Specification No. 203-HJT-~~9000R09000R1a~~

Specification for a Pump System for the High Power Mercury-Jet Target Experiment

~~August 24~~Nov 1, 2005

**SPECIFICATION FOR A PUMP SYSTEM FOR THE
HIGH POWER MERCURY-JET TARGET EXPERIMENT**

Figure 1. Syringe pump subsystem.

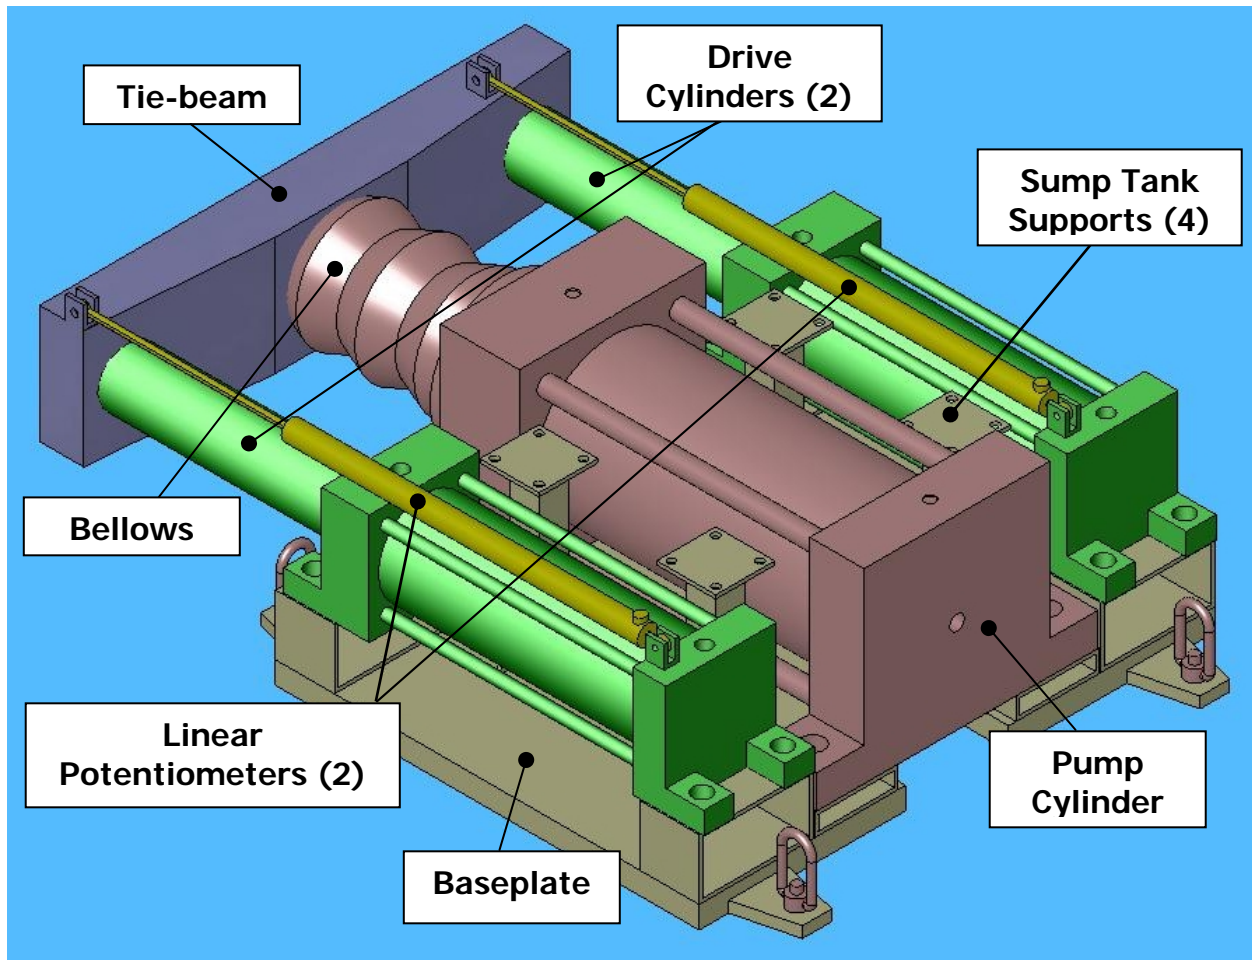
Figure 1 shows the syringe pump; the two outer hydraulic cylinders drive a center cylinder that will produce a jet of mercury at the Company's testing site.

Figure 4. Syringe pump size constraints (dimensions in inches)

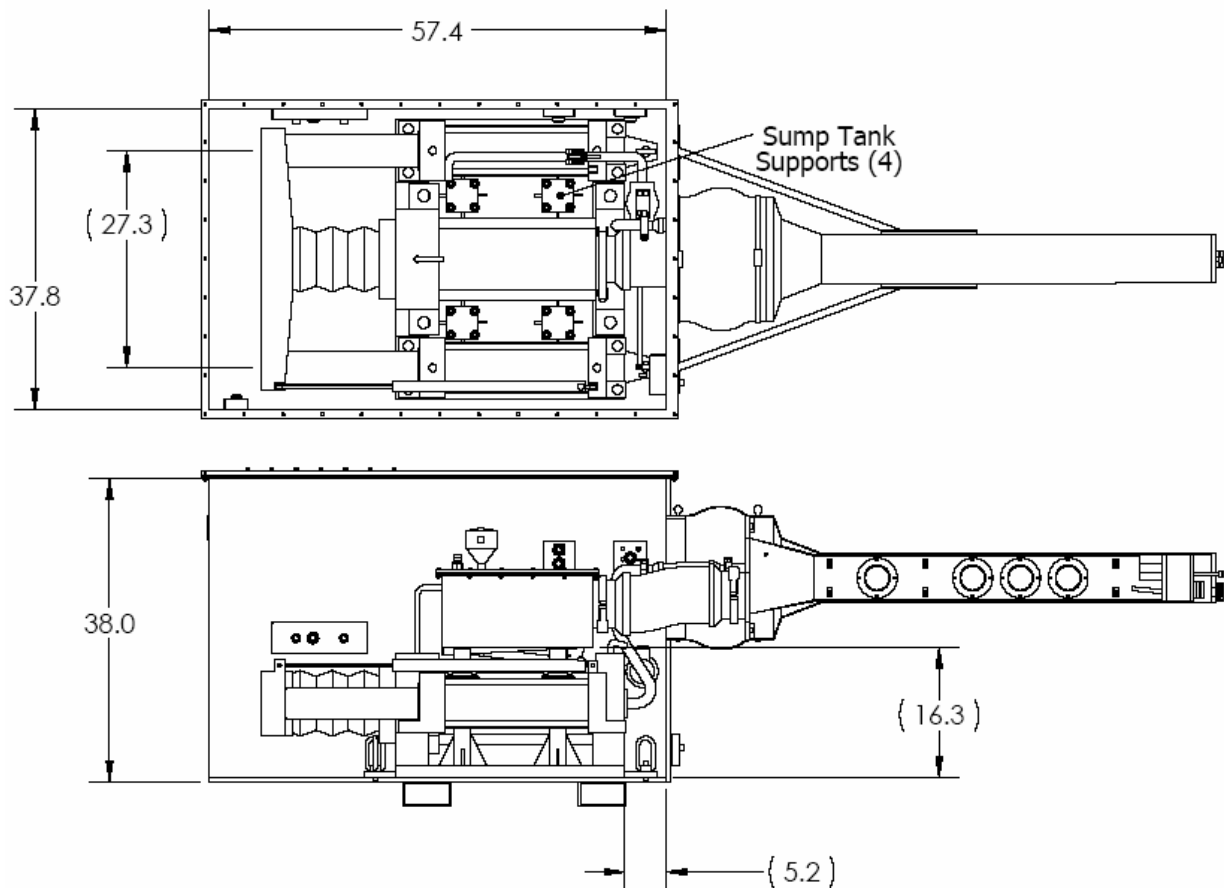
The syringe pump shall be designed to fit within the secondary containment box of the mercury delivery system as shown in Figure 4. Maximum syringe pump width is 35 inches, and the maximum syringe pump extended length is 50 inches. Maximum overall height of the syringe pump is 18 inches.

4.2.4.2 The base support structure shall include four leg supports for a sump tank (that is not part of this procurement); the leg supports shall be designed to support 1000 lbs. at a height of two inches above the pump cylinder. See Figure 4 for interface dimensions.

Fig. 5. Syringe Pump Schematic

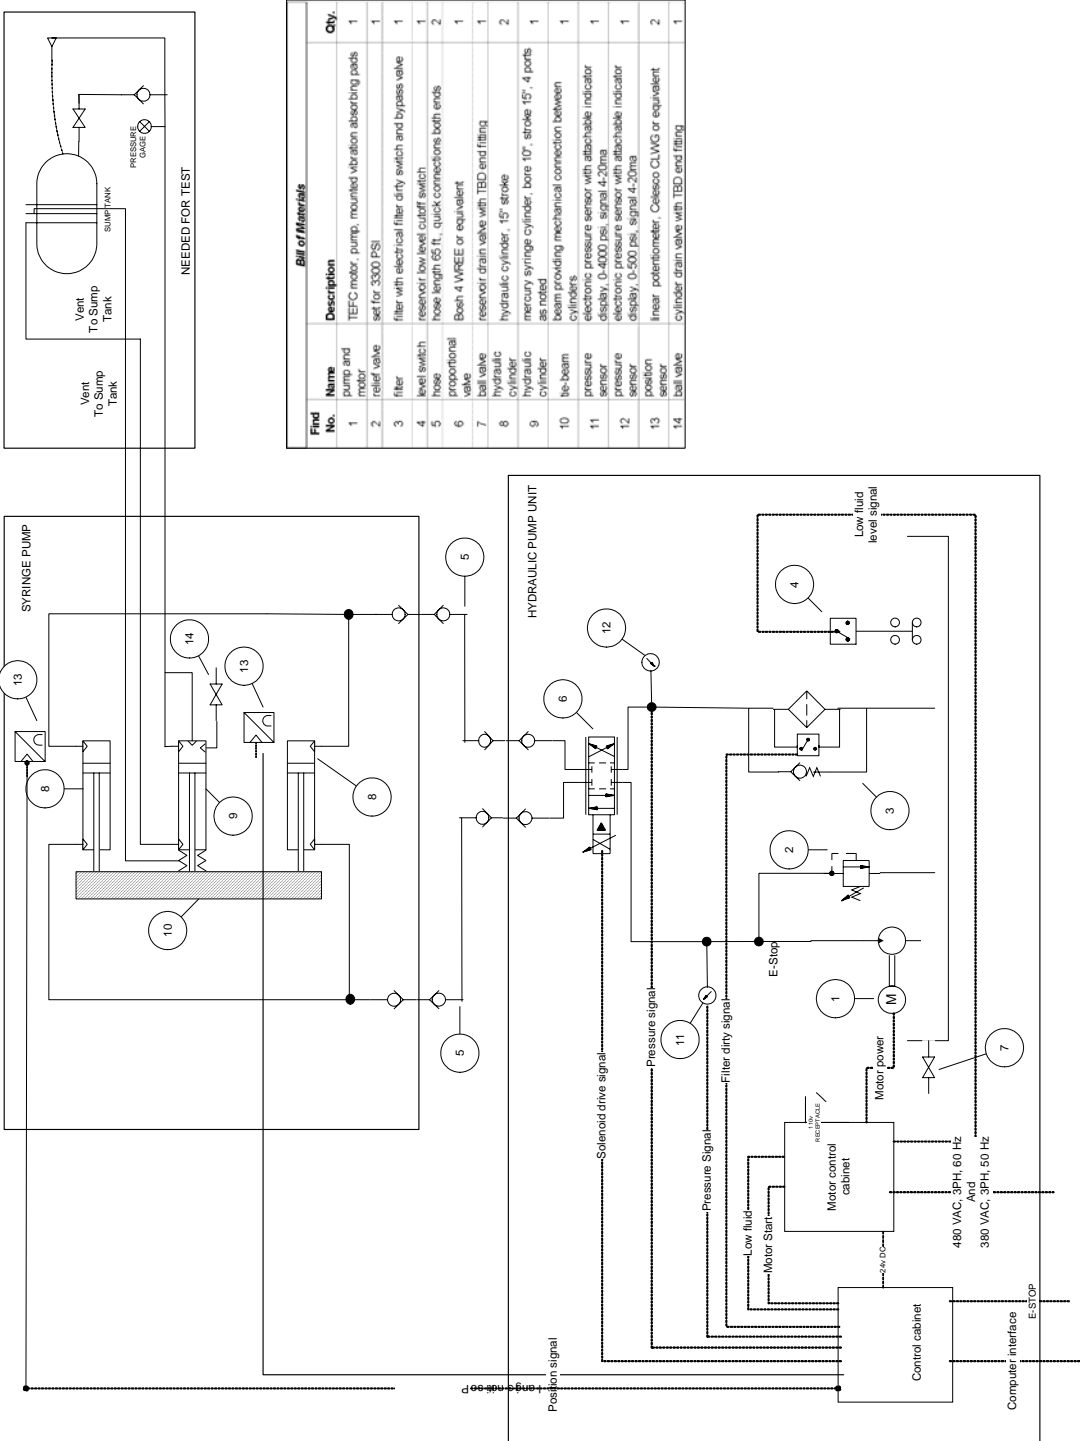
4.1.2.6 Hoses – One pair of hoses shall connect to the reservoir to form the supply and return lines; these shall be split into two pairs inside the secondary containment of the mercury delivery system (see Figure 5), with each pair connecting to one of the drive cylinders. The supply and return lines shall terminate at the reservoir and the secondary containment boundary with male/female fittings, with opposite sex fittings chosen to eliminate the possibility of incorrect hookup. The supply and return hoses shall have check valve quick-disconnect ends, and be a minimum of 65-100 ft. in length. Hoses shall incorporate OSHA-approved whip checks at the disconnects. No magnetic materials are

4.2.2.6 Containment - A boot (soft bellows) shall be provided to cover the extracted piston rod of the pump cylinder. The boot material and its connecting hardware must be compatible with mercury and shall serve as a vapor filter. A vent port shall be provided to allow routed-venting of the boot cover. See Fig. 5.

Pressure sensors with local display and remote output capability (4-20mA output signal) shall be located at the pump discharge and inlet ports. See Fig. 5.

Final acceptance tests of the syringe pump system shall be based on the tests outlined in the Test and Inspection Plan. The test setup shall include those items shown in Figure 5 as "*Needed for Test.*" Distilled water shall be used as the test fluid in the pump cylinder. At a minimum the acceptance tests shall demonstrate
